COMPLETE MONOGRAPH

2021 GROUP A PROPOSED CHANGES TO THE I-CODES

April 11 – May 5, 2021
Virtual Committee Action Hearings

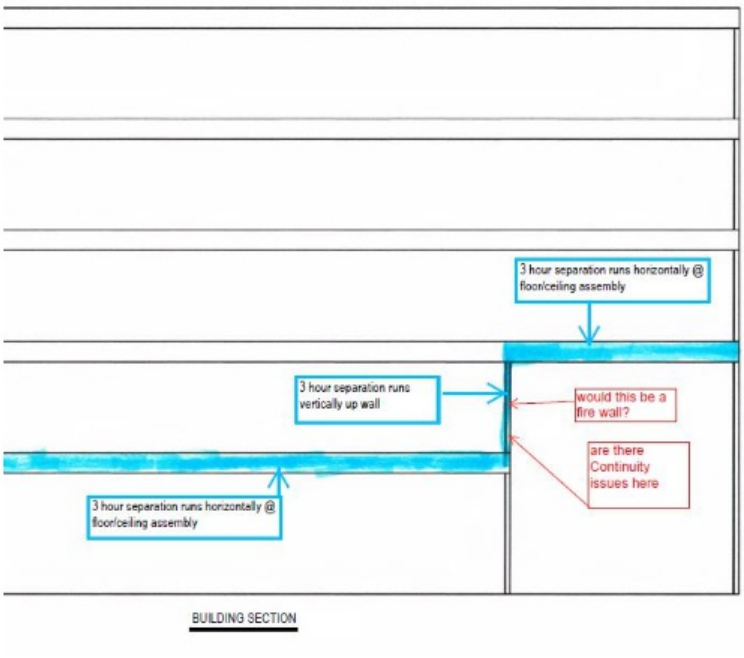
Reason Statement: The code provides for the allowance of vertical offsets in horizontal building separations, but does not clarify how the separation must be constructed other than to also be 3-hour rated. This code proposal fills in the gap so that users know what type of assembly must be used, fire barriers, and subsequently how to address openings, penetrations, joints, continuity, etc. This also clarifies that the vertical offset must also be Type 1A construction just like the horizontal assembly does.

Figure 601(2)
PROTECTION OF ROOF CONSTRUCTION

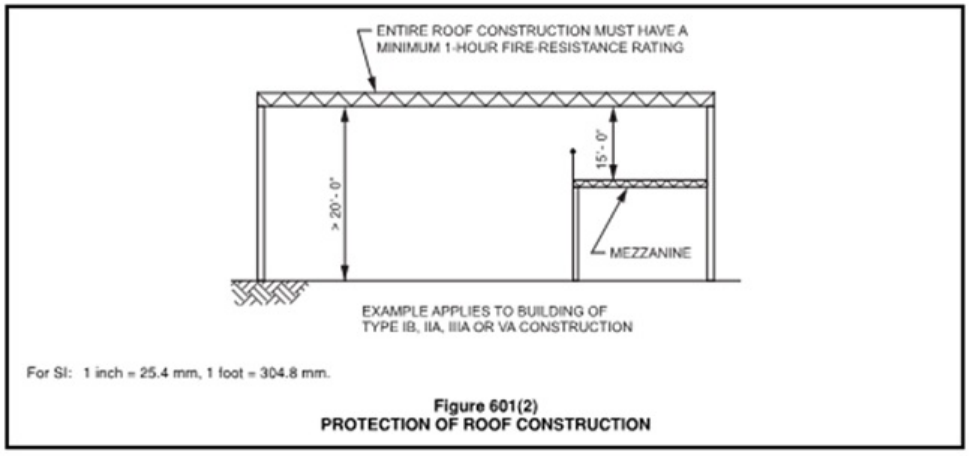
Reason Statement: This section of the code seems to cause a lot of confusion in the field, according to reports to the National Fireproofing Contractors Association. The purpose of this proposal is to bring a key point from the IBC Commentary into the code. It seems the commentary has a graphic that depicts a mezzanine to show visually what this section means -- that the mezzanine located less than 20' below the roof - triggers fire protection of structural members.

FIGURE 3115.3.2
MARKING IDENTIFICATION AND LIKELY LAYOUT

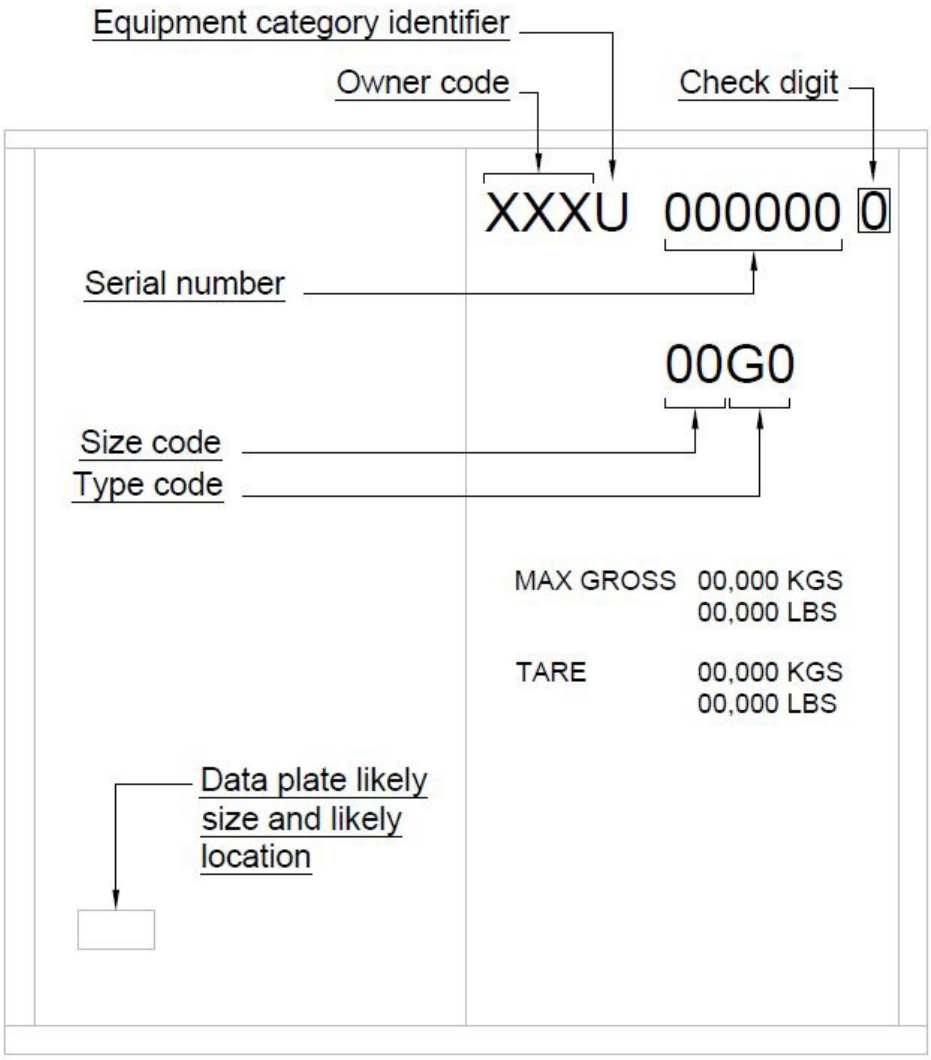
3115.3.2 Intermodal shipping container markings. *Intermodal shipping containers* shall have markings, separate from the data plate, containing the following information. Refer to Figure 3115.3.2 for an example layout of the markings.

FIGURE 3115.8.3.4
CONTAINER ELEMENT IDENTIFICATION

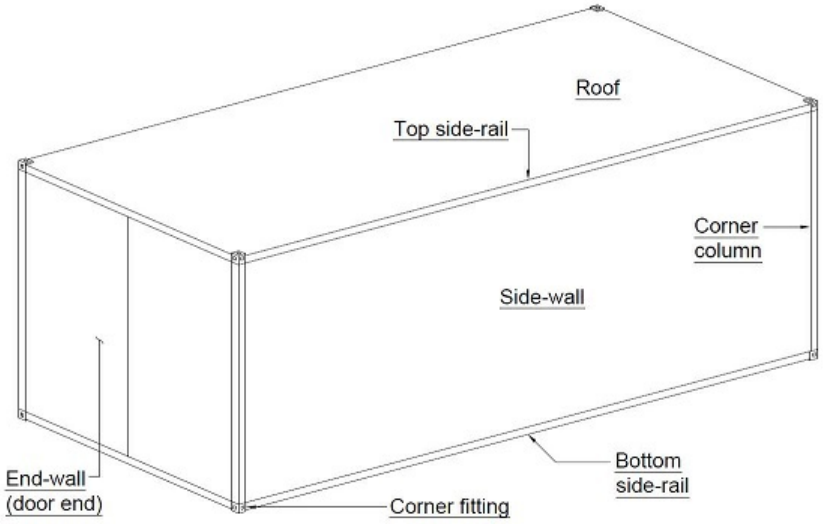
The components names are labeled in Figure 3115.8.3.4.
